STATE OF NORTH CAROLINA
DEPARTMENT OF TRANSPORTATION

SUBJECT: Request for Modification of the Phased Section 404 Individual Permit and Section 401 Individual Water Quality Certification, Neuse River Riparian Buffer Authorization for the construction of the Triangle Expressway Southeast Extension from NC-55 Bypass in Apex to I-40, Wake and Johnston Counties. TIP Nos.: R-2721, R-2828, and R-2829. Federal Aid Project No. 0540047.

PERMIT DRAWING
SHEET 1 OF 112

WETLAND AND SURFACE
WATER IMPACTS PERMIT

**BUFFER DRAWING
SHEET 13 OF 34**

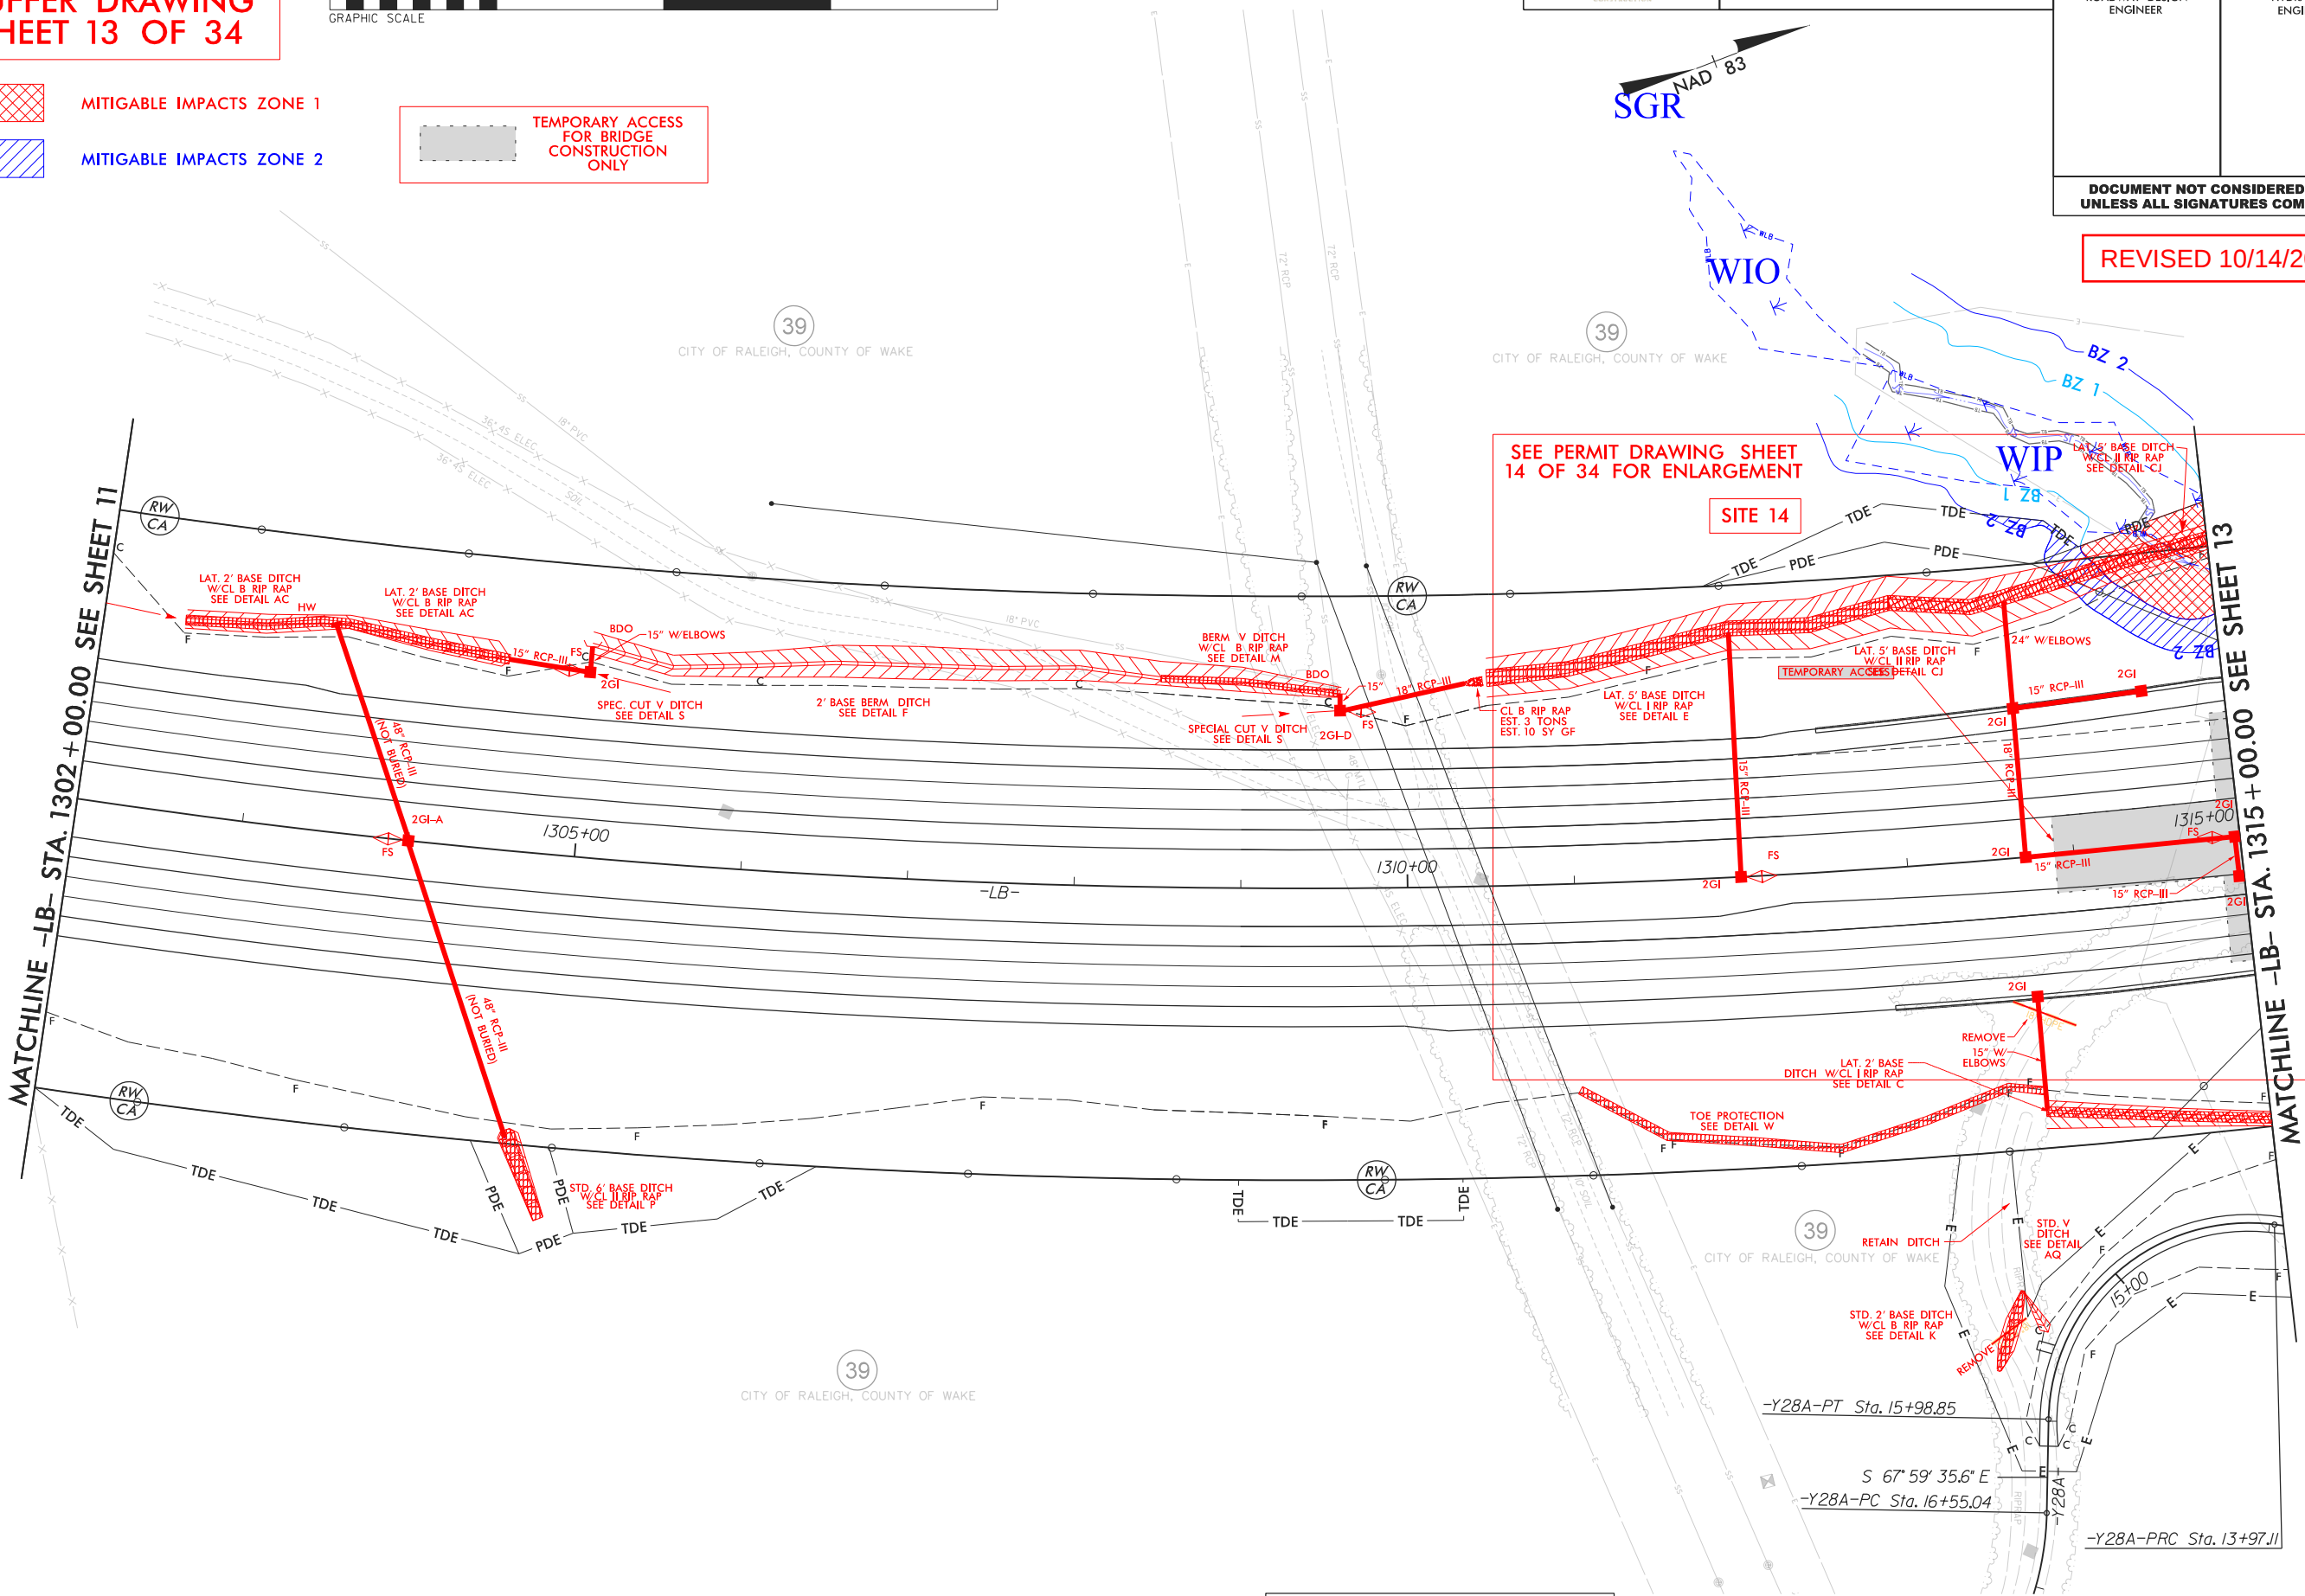
Site 14: WIP and SGR

- Fill in Wetland: 0.036 ac (previously 0 – increase of 0.036 ac)
- Excavation in Wetland: 0.021 ac (previously 0.002 – increase of 0.019 ac)
- Mechanized Clearing in Wetland: 0.030 ac (previously 0.011 – increase of 0.019 ac)
- Permanent Surface Water Impacts: 500 lf (previously 442 – increase of 58 lf)
- Buffer Zone 1 Impacts: 27,754 sq ft (previously 24,910 sq ft – increase of 2,844 sq ft)
 - Wetlands in Zone 1 (WIP): 1,611 sq ft (previously 40 sq ft – increase of 1,571 sq ft)
- Buffer Zone 2 Impacts: 18,077 sq ft (previously 16,255 sq ft – increase of 1,822 sq ft)
 - Wetlands in Zone 2 (WIP): 1,280 sq ft (previously 156 sq ft – increase of 1,124 sq ft)

BUFFER DRAWING
SHEET 25 OF 34

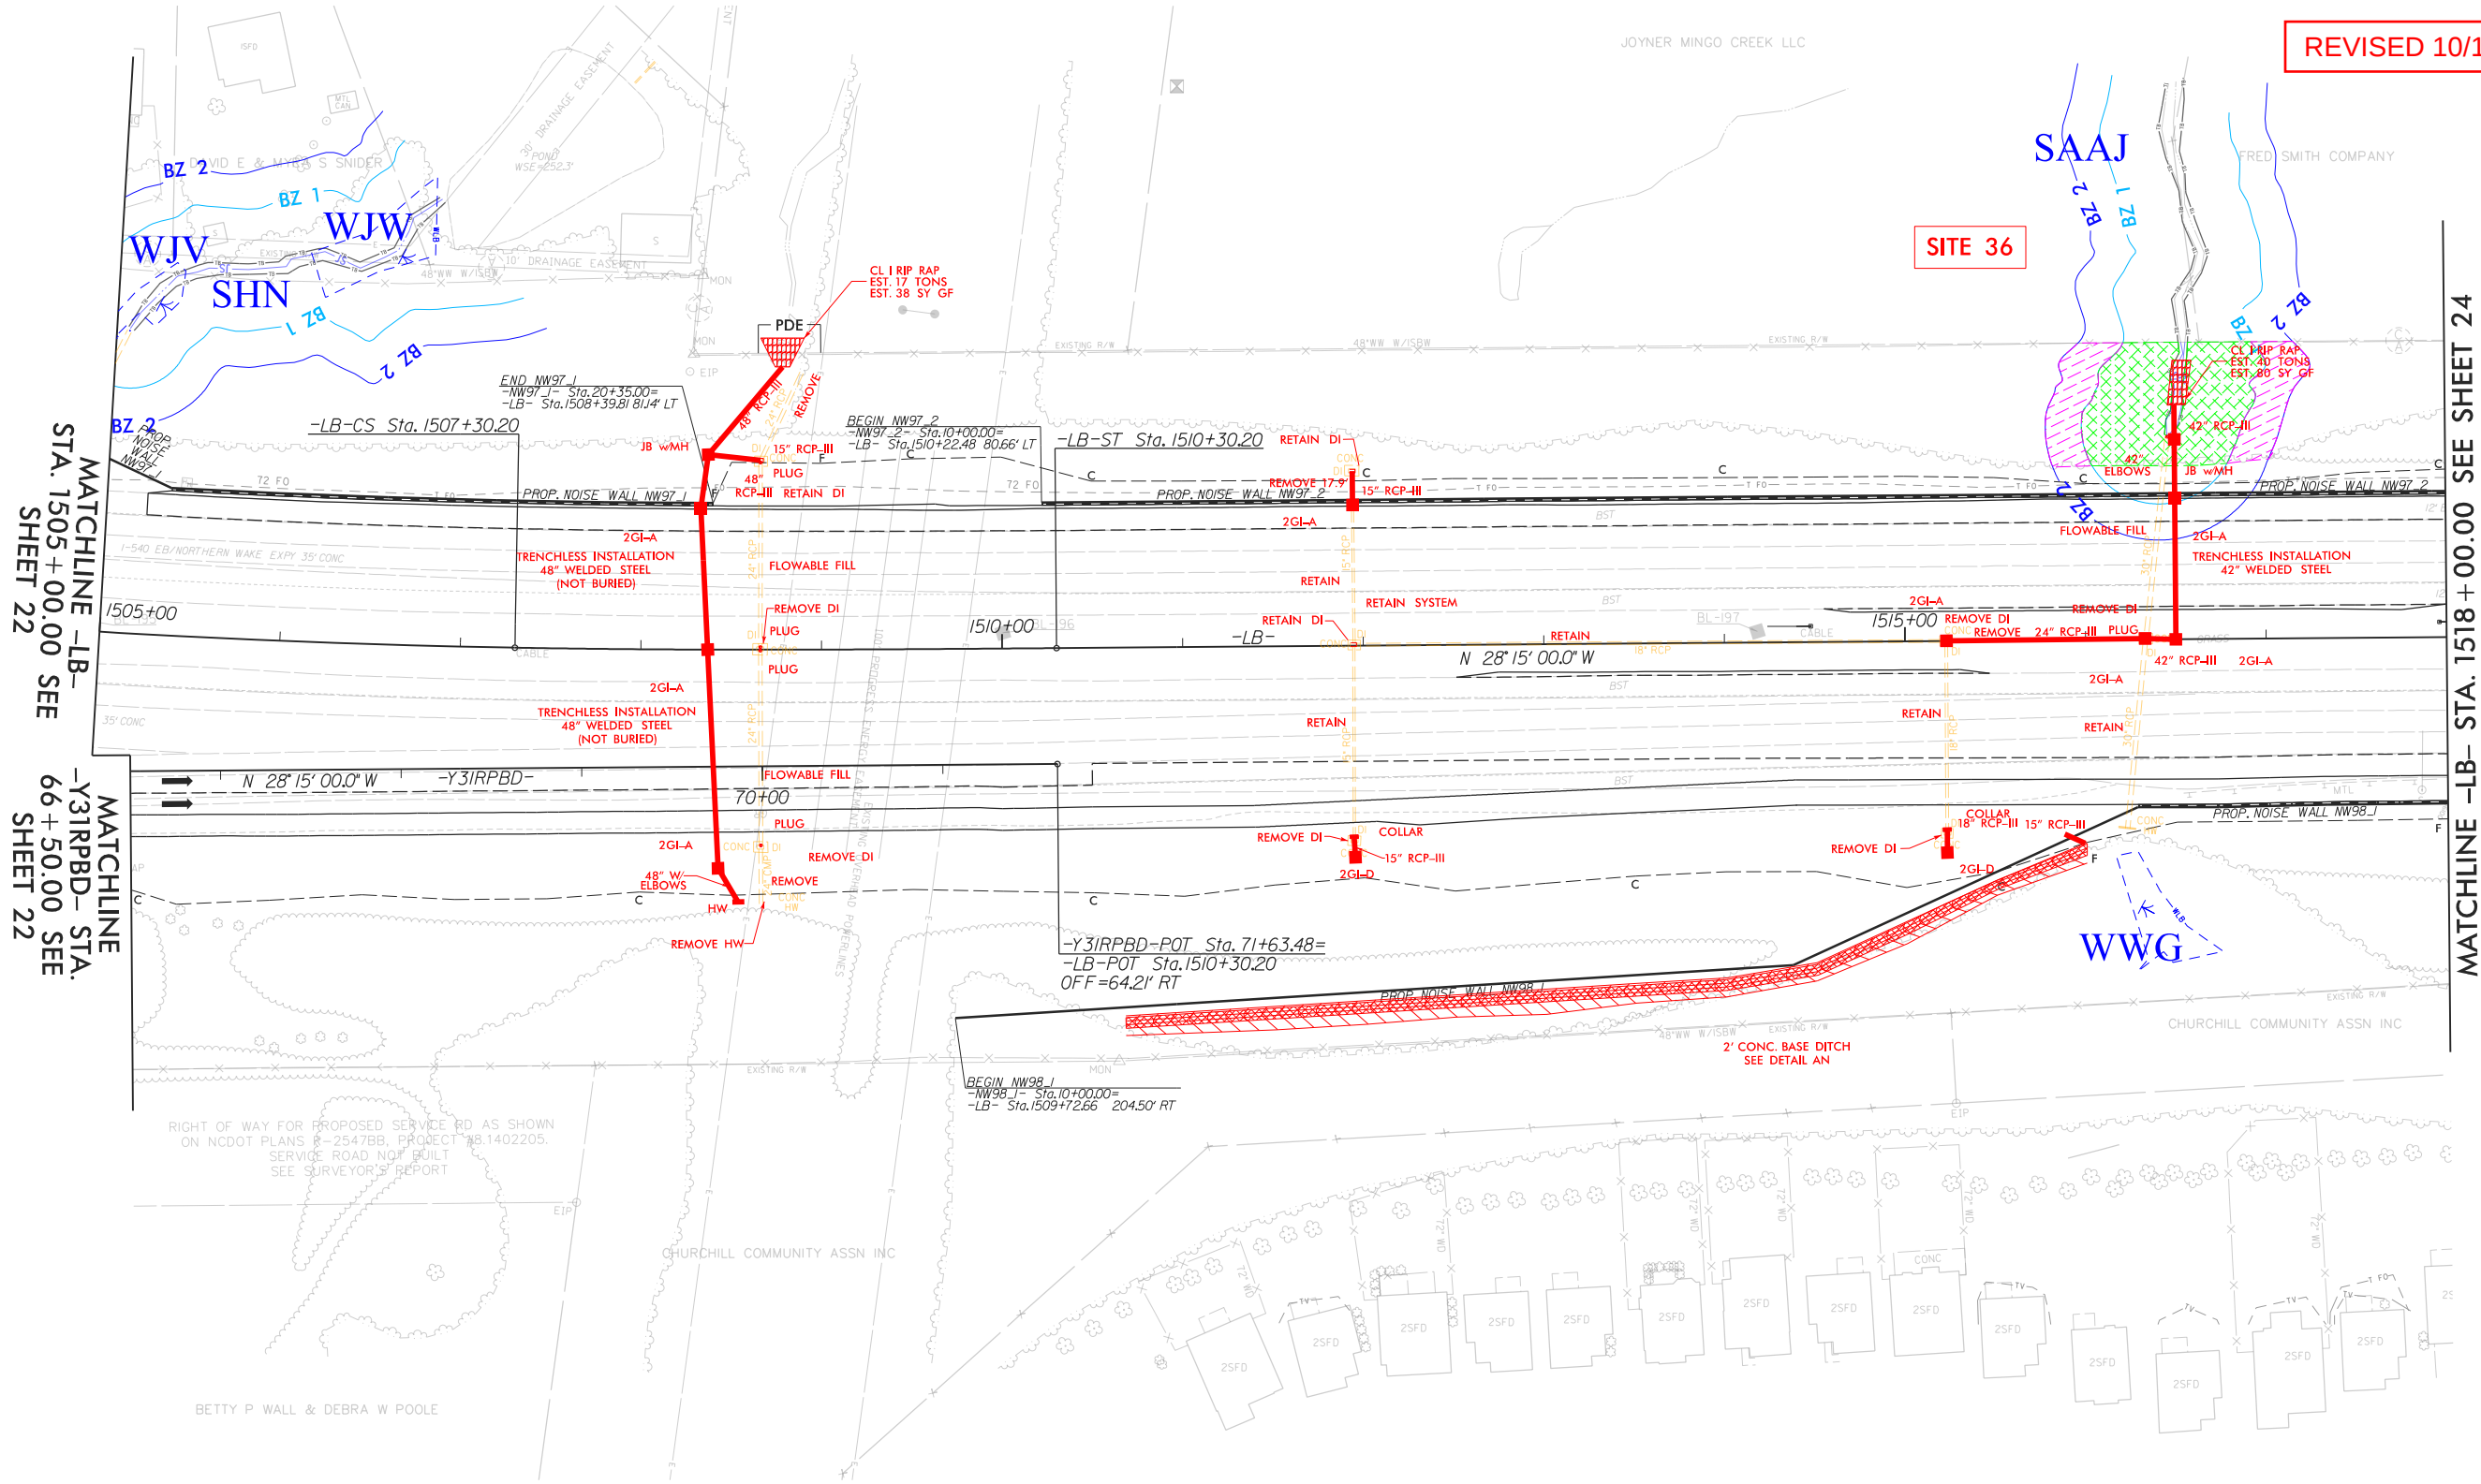
Site 36

- Buffer Zone 1 Impacts: 5,421 sq ft (previously 3,038 sq ft – increase of 2,383 sq ft)
- Buffer Zone 2 Impacts: 2,836 sq ft (previously 0 sq ft – increase of 2,836 sq ft)

Additional Zone 1 and Zone 2 Buffer Impacts are required to allow for construction access to construct the proposed pipe and riprap scour and channel protection. The site requires access parallel to the existing NC 540 lanes, necessitating the impact to the Zone 1 and 2 Buffers, which should be Allowable Upon Authorization considering this is an existing transportation facility.
